REGULATORY INFORMATION DISTRIBUTION SYSTEM (RIDS)

SUBJECT: Forwards NIS-1 Rept for Inservice Insp activities performed at facility.

SUBJECT: DONALD C. COOK NUCLEAR PLANT, UNITS 1 AND 2 RE: CONFIRMATORY
ORDER MODIFYING POST-TMI REQUIREMENTS PERTAINING TO
CONTAINMENT HYDROGEN MONITORS (TAC.NOS. MA7761 AND MA7762)

SUBJECT: ISSUANCE OF AMENDMENTS - DONALD C. COOK NUCLEAR PLANT, UNITS 1
AND 2, RE: MOVEMENT OF STEAM GENERATOR SECTIONS IN THE
AUXILIARY BUILDING FOR STEAM GENERATOR REPLACEMENT PROJECT
(TAC NOS. MA6665 AND MA6666)

Figure 5.6-4: New Fuel Storage Rack Integral Fuel Burnable Absorber (IFBA) Requirements

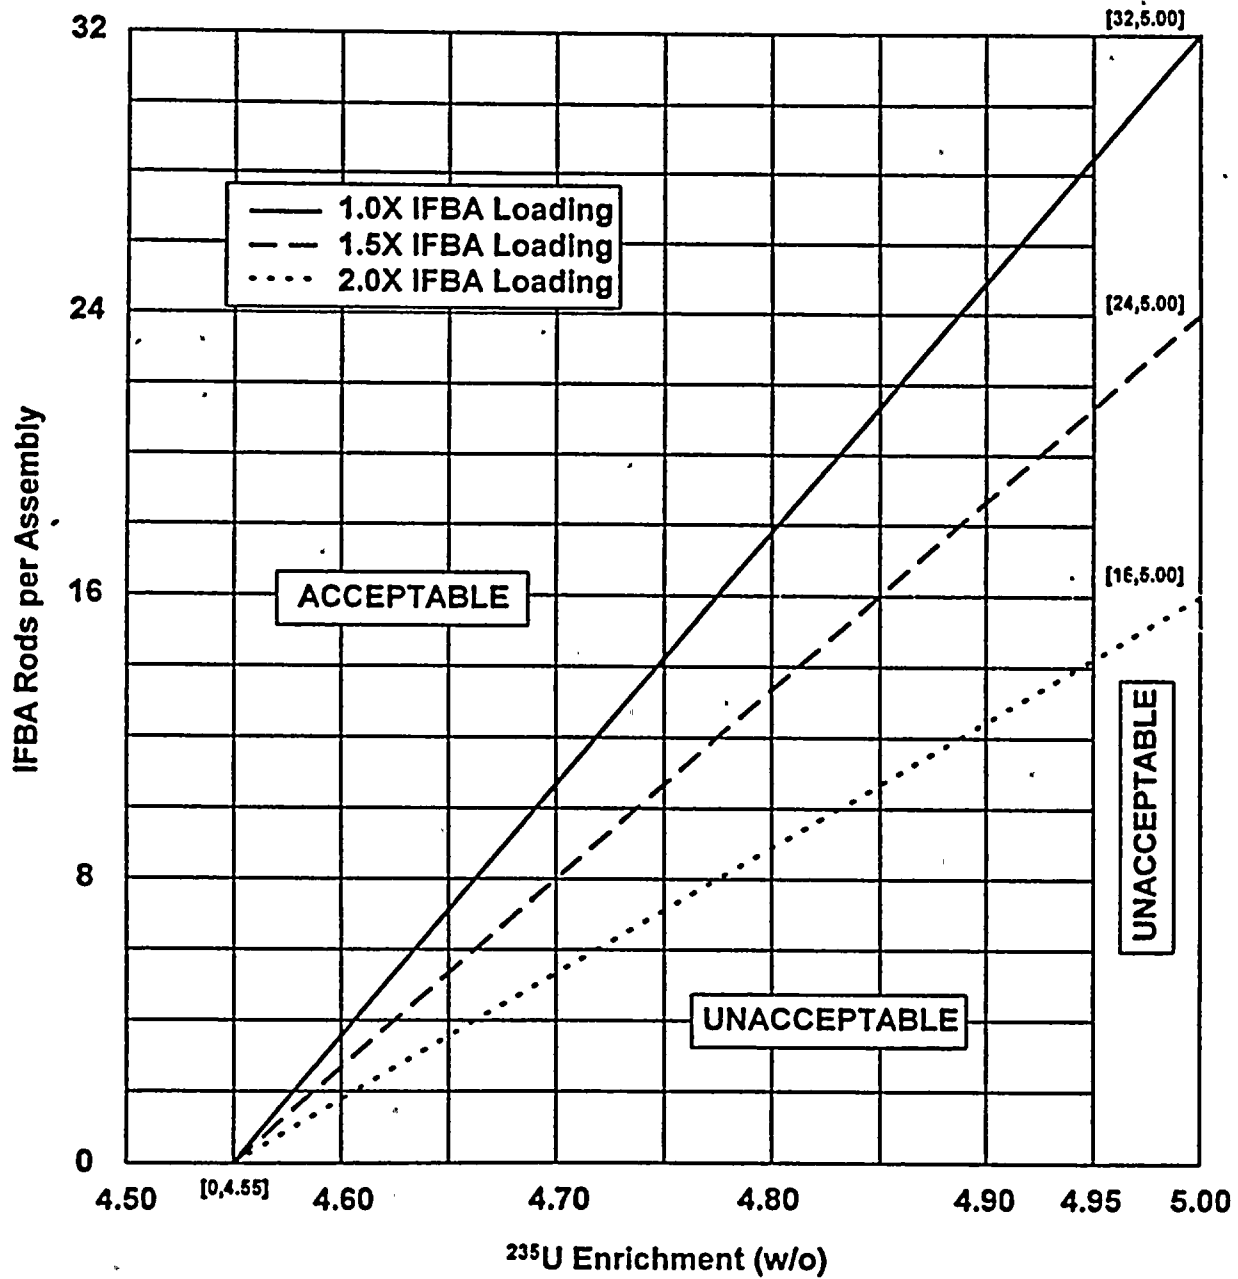
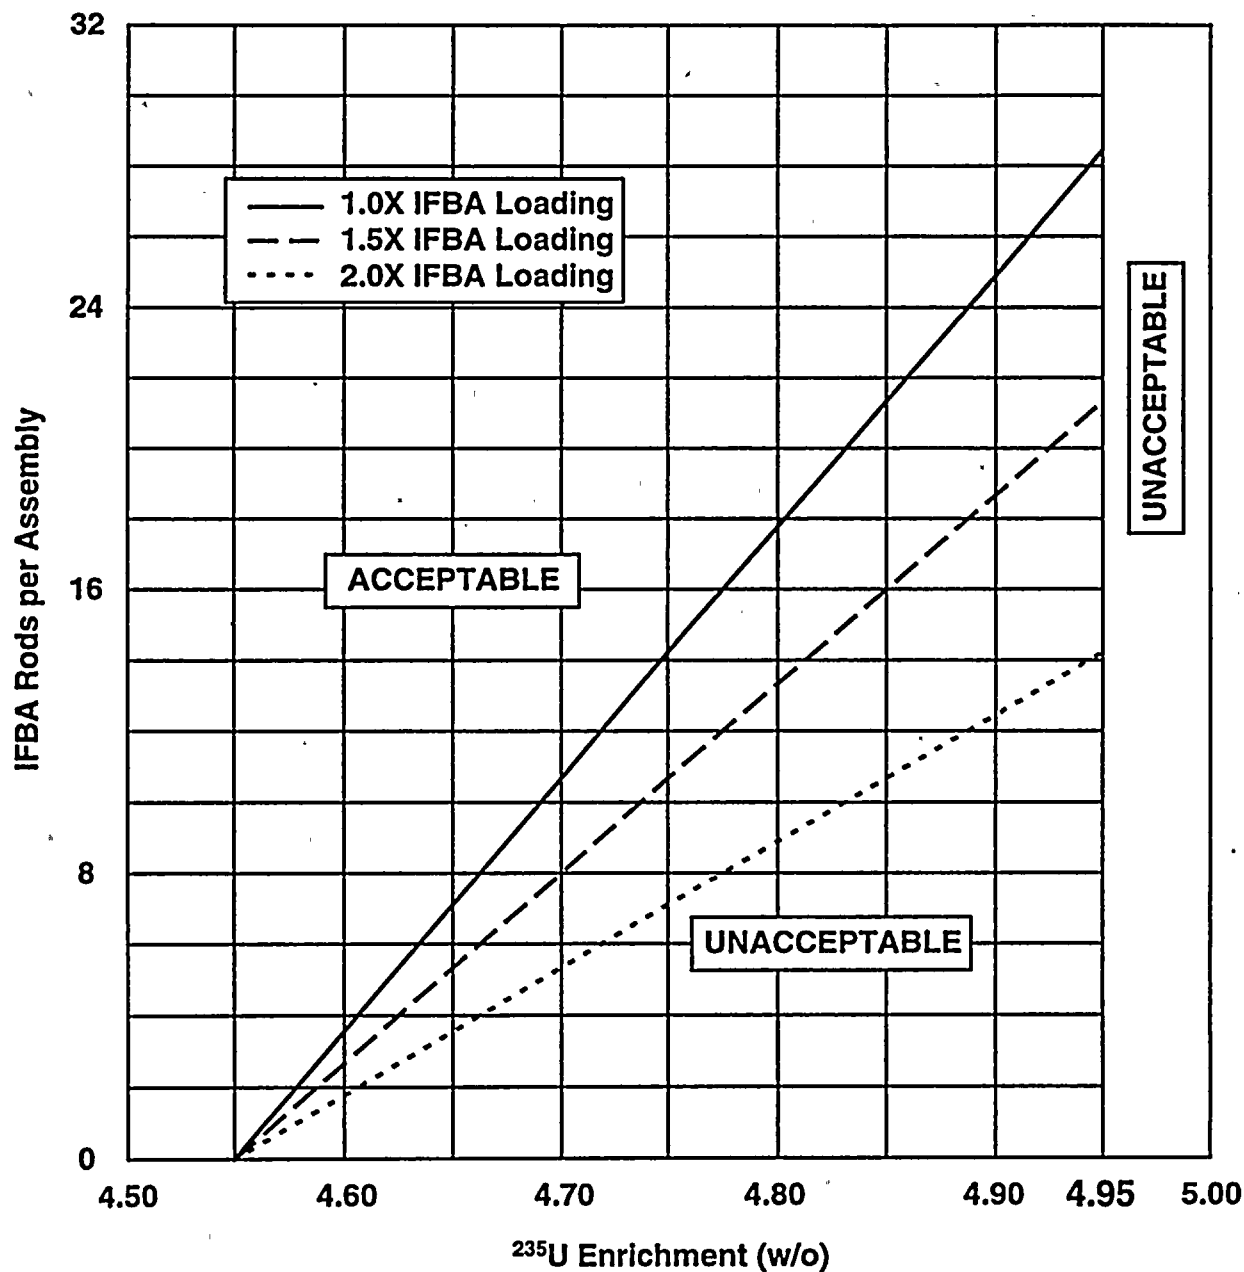
The licensee proposes to revise TS 5.6.2.a and add a new TS Figure 5.6-4, "New Fuel Storage Rack Integral Fuel Burnable Absorber (IFBA) Requirements," to specify maximum enrichments and IFBA requirements for Westinghouse fuel in the new fuel storage racks. Specifically, TS 5.6.2.a is proposed to state that the new fuel storage racks are designed and shall be maintained with "Westinghouse fuel assemblies having either a maximum enrichment of 4.55 weight % U-235, or an enrichment between 4.55 and 4.95 weight % U-235 with greater than or equal to the minimum number of integral fuel burnable absorber pins as shown on Figure 5.6-4 (interpolation of the Boron-10 loading between 1.0X and 1.5X and between 1.5X and 2.0X is acceptable)." The new TS Figure 5.6-4 specifically covers IFBA requirements between 4.55 and 4.95 weight % U-235. The licensee proposes to delete the footnote for TS Table 5.6-1 since it is superseded by the proposed change to TS 5.6.2.a.

New TS Figure 5.6-4 is based on the reactivity equivalencing calculational method described in CDB-95-175, which was previously reviewed and approved by the NRC for Amendment Nos. 213 and 198. Use of this method ensures the required reactivity margin is maintained for storage of Westinghouse fuel assemblies in the new fuel storage racks. Therefore, the staff considers the proposed method for determining IFBA requirements and resulting TS changes acceptable.

FIGURE 1 SCHEMATIC DIAGRAM OF D. C. COOK UNITS 1&2 PRIMARY LOOP SHOWING WELD LOCATIONS

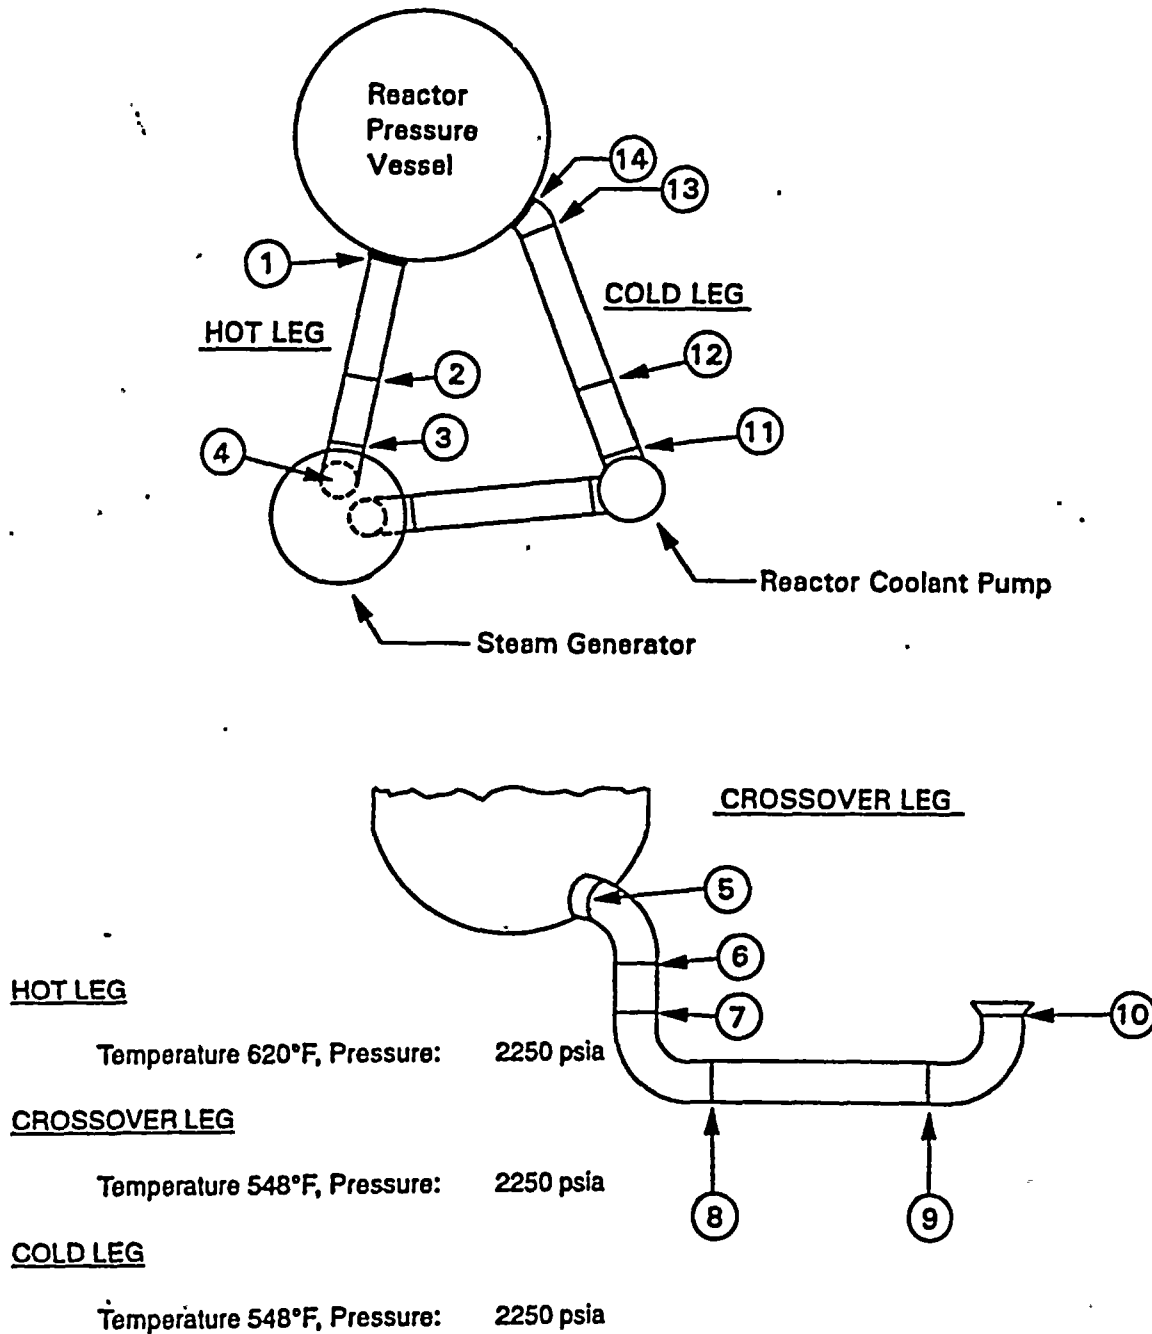
Next, the licensee determined the appropriate loading conditions to be used for the analysis. The licensee calculated the total piping stress at the fourteen locations identified in Figure 1 from the algebraic sum of the forces and moments due to deadweight, thermal expansion, and pressure loads during normal 100 percent power operation. These loads, herein called the "NOP" loads, along with the corresponding pipe dimensions at the fourteen locations, are given in Table 1. The licensee then calculated the total piping stress at the fourteen locations from the absolute sum of the forces and moments due to deadweight, thermal expansion, pressure loads during normal 100 percent power operation, and SSE inertial and anchor motions. These loads, herein called the "NOP+SSE" loads, for each location are given in Table 2. Based on an

evaluation of these loads, the licensee determined that the limiting locations for the LBB analysis would be locations 1, 10, and 11, as shown in Figure 1.
